Bid Bulletin No. 8
17 September 2021

PUBLIC BIDDING No. 21-119-5

SITE DEVELOPMENT OF 100-HECTARE AREA AT
BATAAN TECHNOLOGY PARK, MORONG, BATAAN

On drawing sheet P 29. 1-1 shows the plan of 350 cu.m. Cistern Tank. The tank dimension is 10000mm x 15000mm. The tank piping have the following:

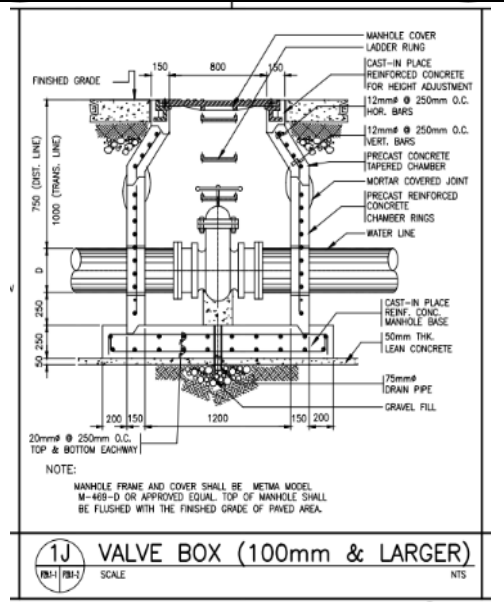
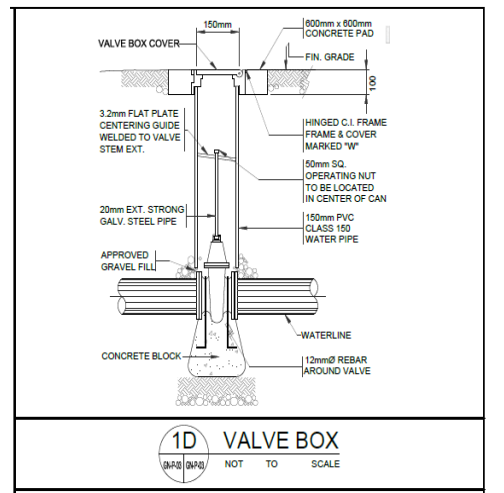
- a) 2 nos. x 150 mm diameter gate valve supply lines in a valve box on the right side.
- b) 2 nos. x 150 mm diameter gate valve supply lines and 2 nos. x 150 mm diameter gate valve distribution lines in a valve box on the left side, in total there 4 nos. valve box on the left side.

As shown, the valve box is not proportionally/scaled drawn either the smaller or larger valve box, Hence, please clarify which details to follow taking into consideration the dimension of the tank is 15m only but will have 4 nos. valve box to be constructed.

RCE GLOBAL CONSTRUCTION INC.³			
6	Bidding Forms	In view hereof, we would like to respectfully confirm and clarify the criteria in the Detailed Estimate portion; are we to fill the Detailed Estimate Form alone or we still need to attach the itemized breakdown of the Detailed Estimate?	The breakdown of the detailed cost estimates should not be attached.
ALMERIA INTERNATIONAL CONSTRUCTION CORPORATION.⁴			
7	Section VII. Drawings	Please clarify the following: Valve Box On drawing sheets P50-2 and P 29.1-2 shows a VALVE BOX with internal diameter of 3000 mm diameter and 1200 mm diameter but both are titled "VALVE BOX (100mm & LARGER)". We assumed that the 1200mm diameter is supposed to be "VALVE BOX (75 mm & SMALLER). Please confirm. 350 cu.m Cistern Tank	Valve Box Please refer to valve box details in drawing sheet no. P29.1-2, as shown on the snipped drawing below, for 100mm & LARGER valves: Valve Box for 100mm & LARGER

For 75 mm and SMALLER valves, please refer to the valve box details below:

Valve Box for 75mm & SMALLER

350 cu.m. Cistern Tank

- a. There are two (2) supply lines (from deep well source) with 150mm gate valves inside the valve box at the right side leading to the two compartments/chambers of the 350 cu.m. cistern tank.
- b. There are four (4) 150mm gate valves inside the valve box at the left side for the following:

<ul style="list-style-type: none"> • Two (2) supply lines coming from Morong Water District leading to the two (2) chambers of Domestic Water Cistern. • Two (2) distribution lines coming from the Domestic Water Cistern to the Water Distribution System.
8	Section VII. Drawings	<p>We would like to clarify with regards to the following:</p> <p>At the Main Gate/ Alternate Entrance/ Exit Gate</p> <ol style="list-style-type: none"> 1. There are walk through metal detectors , 8 units in the drawing but are not included in the BOQ. 2. There are 32 car bar stopper in the drawing but not included in the BOQ. 	<ol style="list-style-type: none"> 1. The walkthrough metal detectors (8 units) will be implemented in the future packages and are not included under this project. 2. The 32 car bar stoppers will be implemented in the future packages and are not included under this project.
